ADDENDUM 1

DATE: June 05, 2017
PROJECT: OCB Storm Drain System Modifications
ITB NO: 744-B1717-OCB Storm Drain System Modifications
OWNER: The University of Texas Health Science Center at Houston
TO: Prospective Proposers

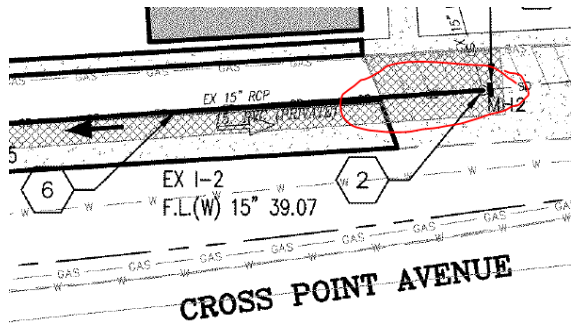
16) Clarification: Note 6 on C-102 states to replace existing 15" RCP with new 15" RCP. This not does not reflect the profile plans which show the 15" RCP to be replaced with 18" PVC. Please clarify.

Response: To my knowledge there is one profile for this run of pipe. The plans provided to the contractor during the walk through has had corrections due to the new alignment on the west side of the site to avoid the existing trees. The 15" plan view and note 6 has been revised to show that the new pipe will be an 18" pipe.

PROPOSED STORM DRAIN MODIFICATION PLAN

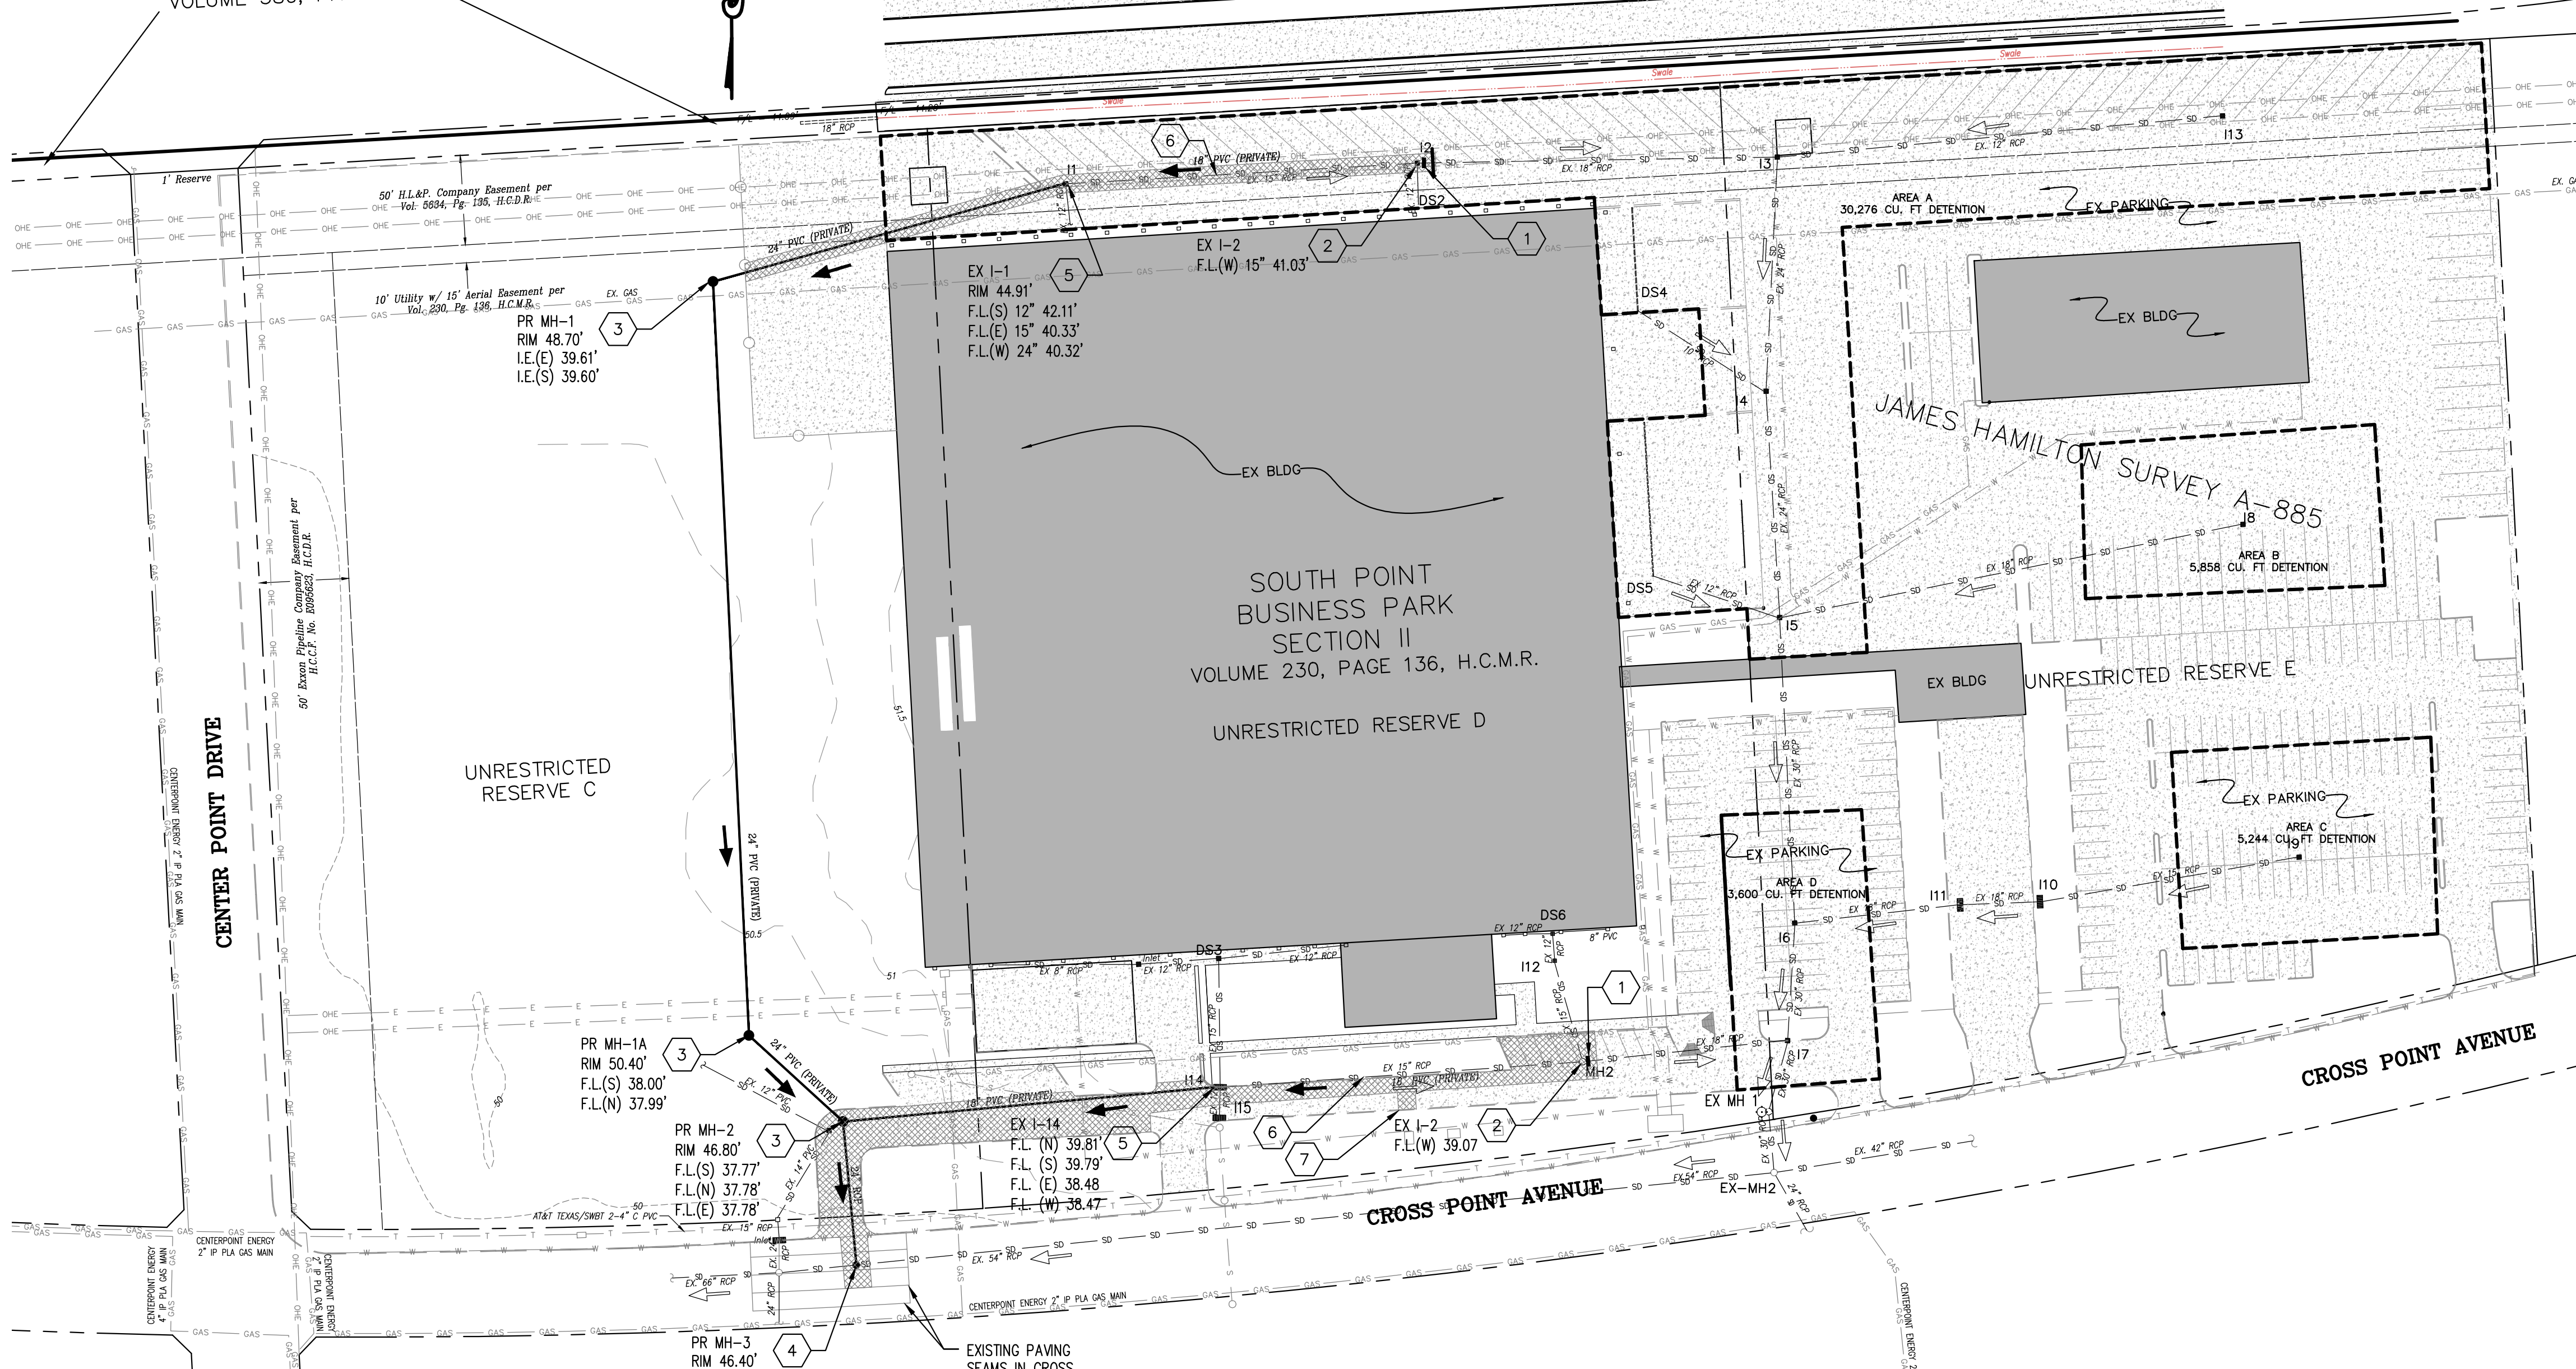
14) Clarification: The proposed route for the 24" storm line on the plan west side of the building will run through a grouping of trees. Please clarify the route, and if any trees are to be relocated/replaced. The proposal route will require the removal of several of the existing trees.

18) Clarification: The proposed storm line to the north is currently located in the powerline easement. Please provide re-route to avoid easement.

Response: The plans have been revised to move the system out of the trees as discussed. The alignment will impact a concrete pad that the client's employees are using for a lunch area. The contractor will work with the Client to determine the new location (if different than the current location) for a new concrete pad of the same size.

Response: The existing system that is being rerouted is in the existing electrical easement and the route provides minimal costs of replacing paving and additional structures. The contractor will have to work with the electrical company to provide protection from the overhead power lines.

DATE: 3-17-2016
 DRAWN BY: MLH
 DESIGN BY: MLH
 JOB NO.:
 SHEET NO.: **P-300**

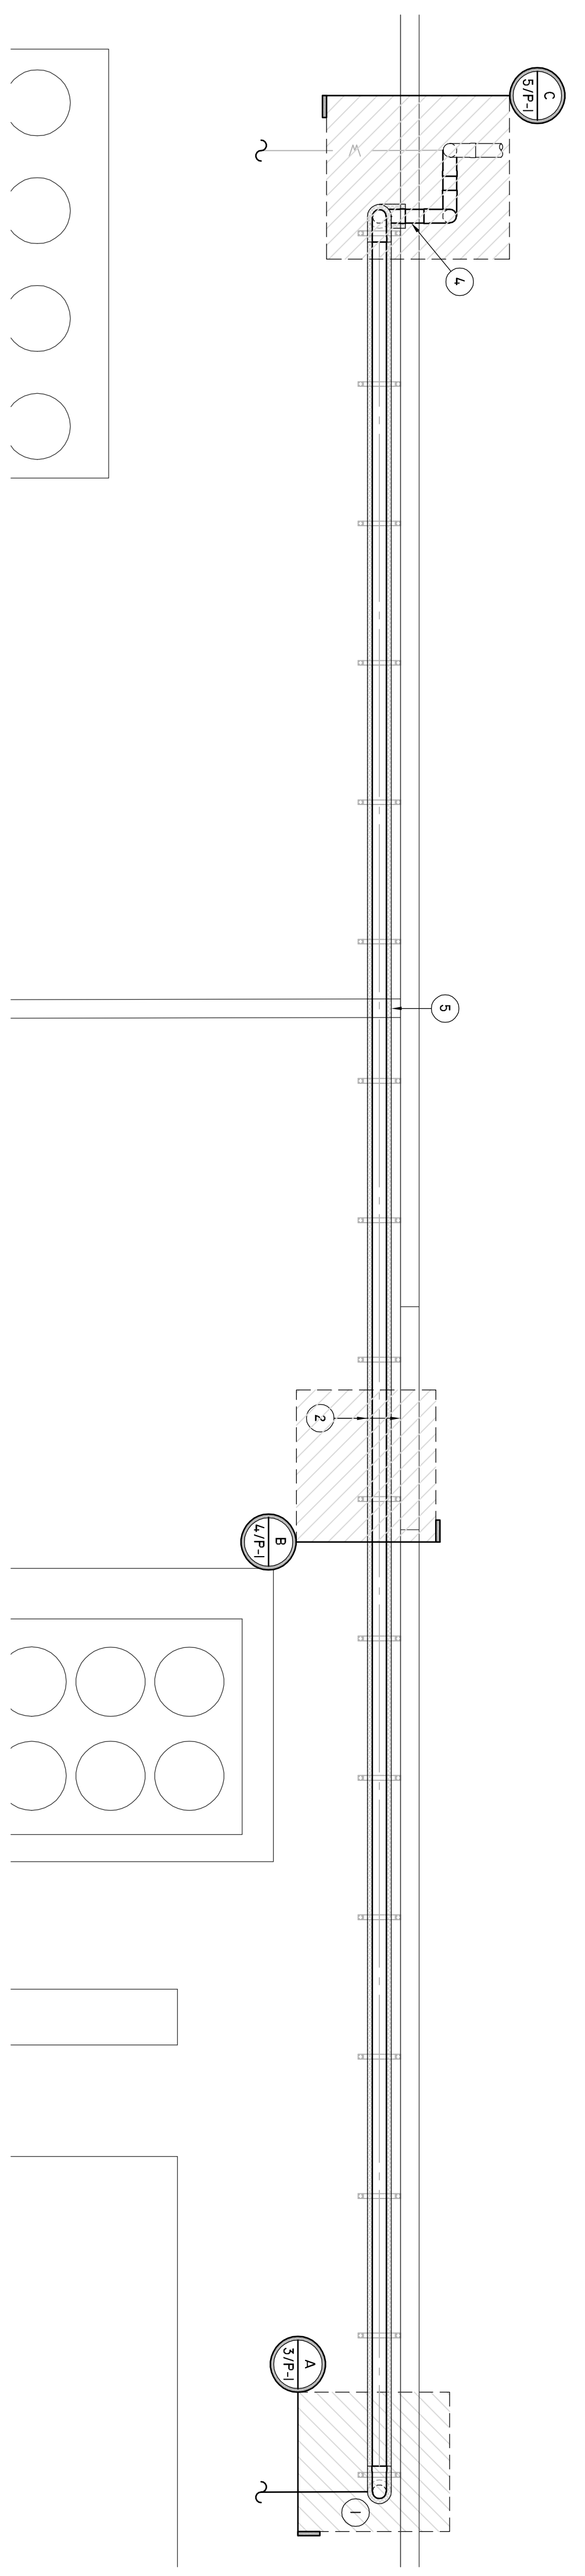
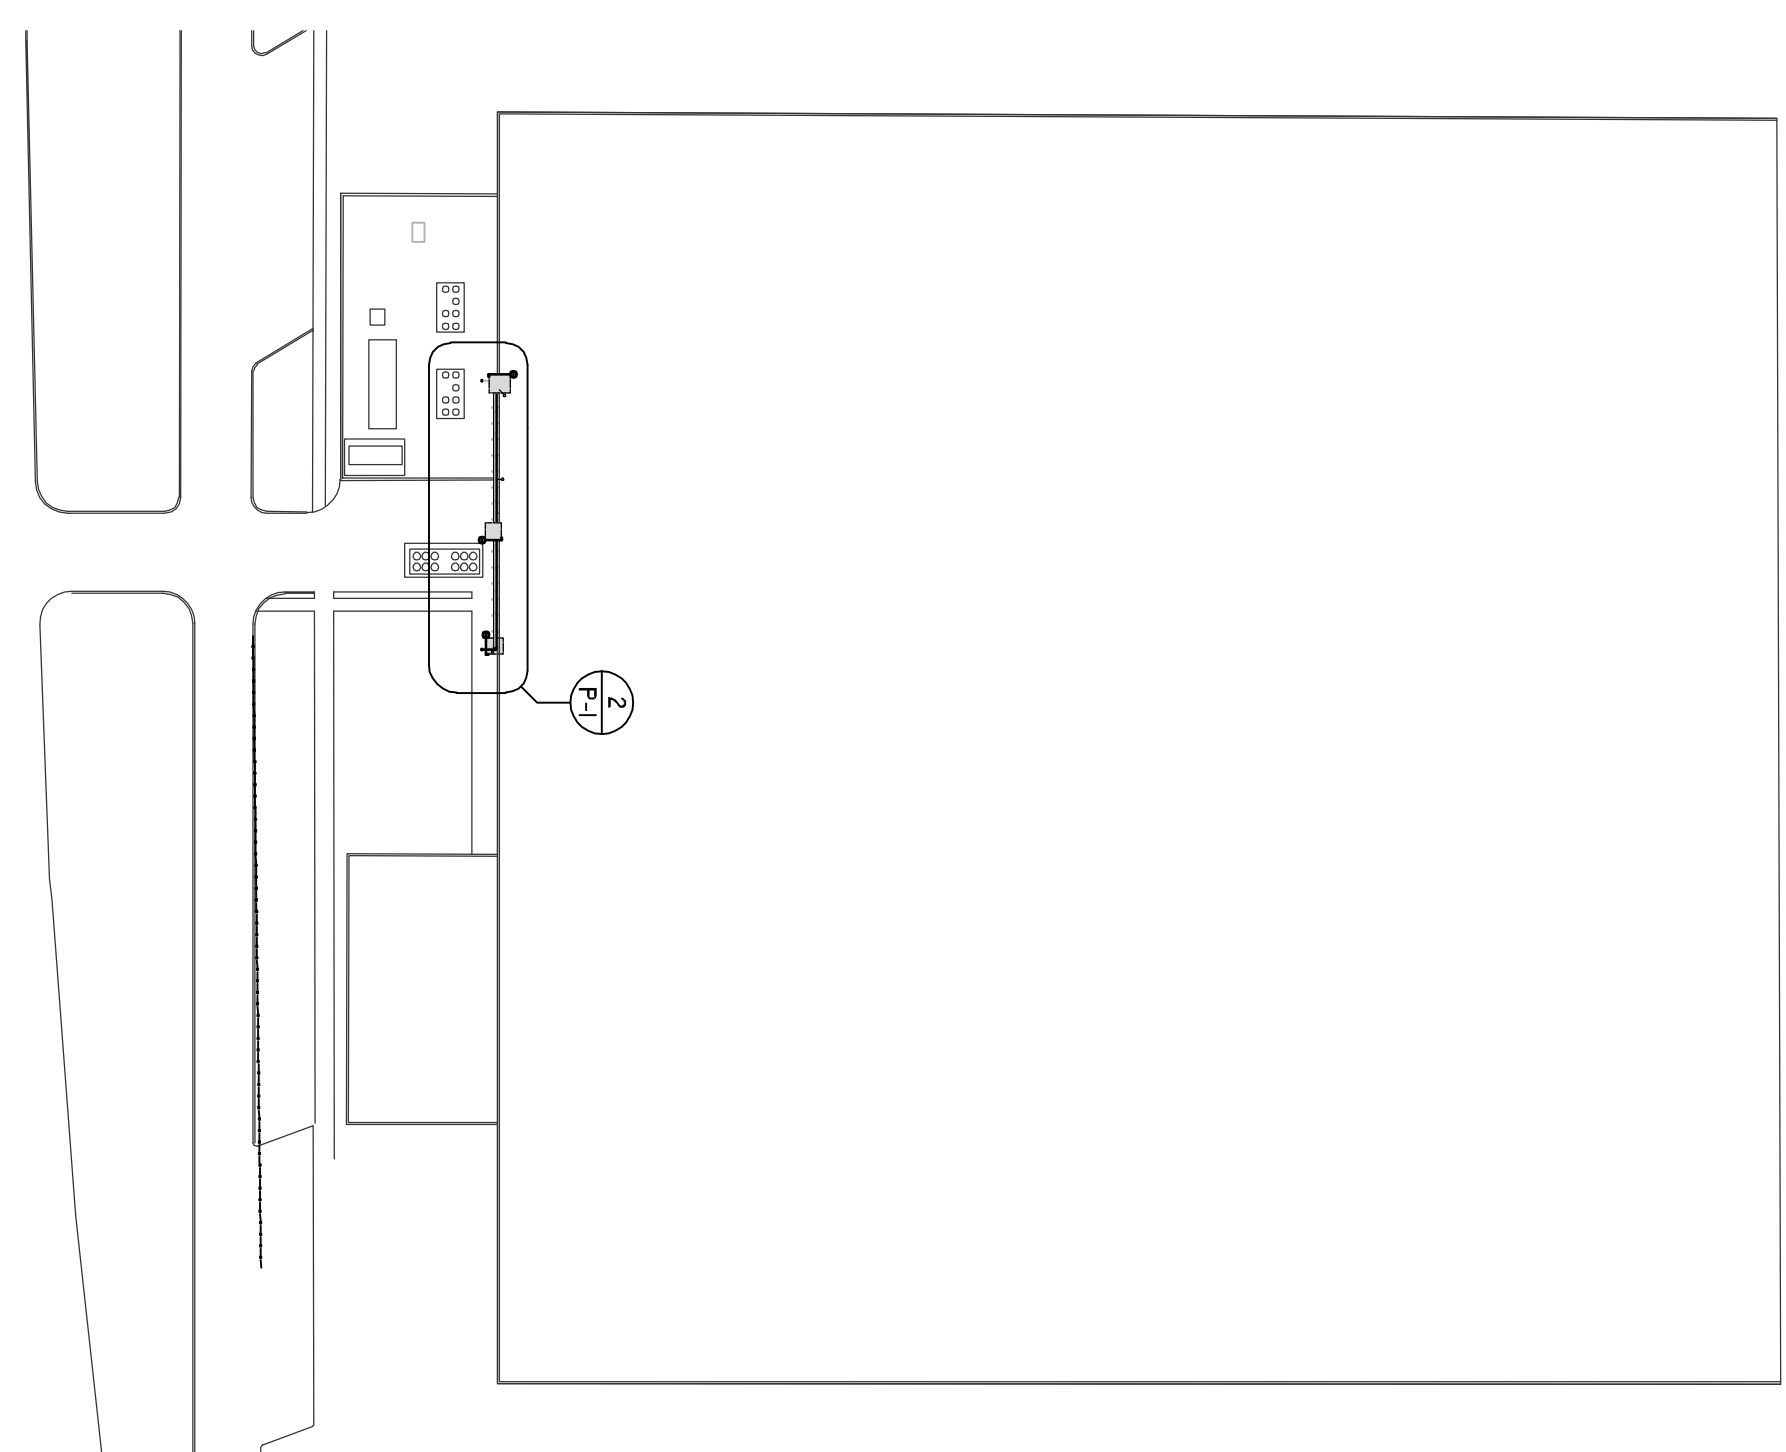
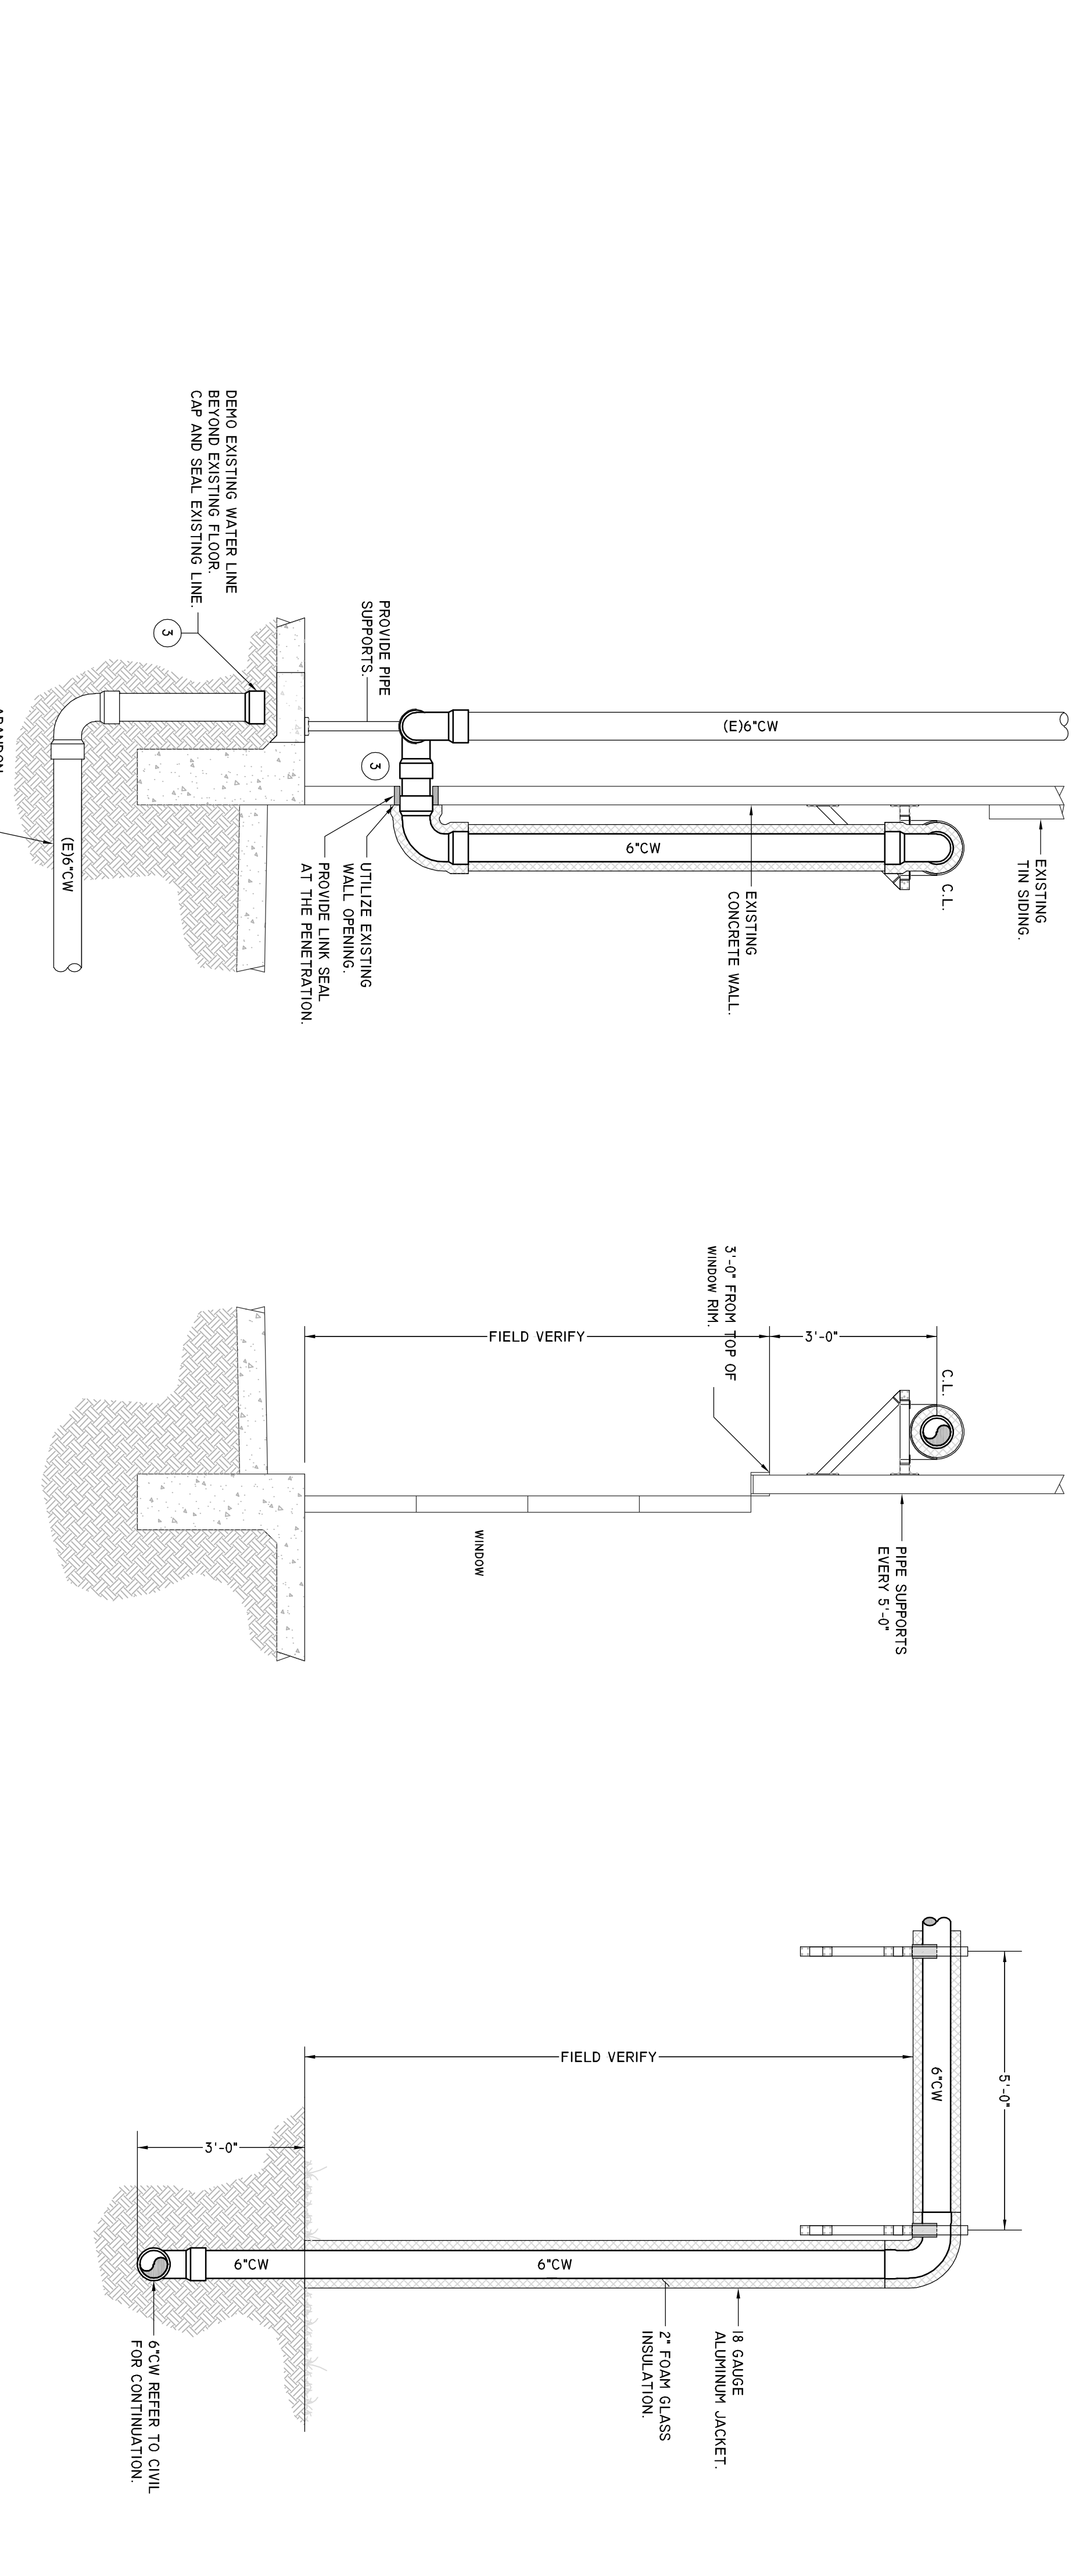
- 11) Clarification: The existing opening referenced on P-300/5 appeared to be closed in during the site walk. Please confirm the contractor can core a new opening for the piping.

Response: Core new opening
- 12) Clarification: Please clarify if the coring of the opening for the plumbing pipe, and the work inside the building for the water pipe connection will be required to be after hours, or if this work can be performed during normal hours.
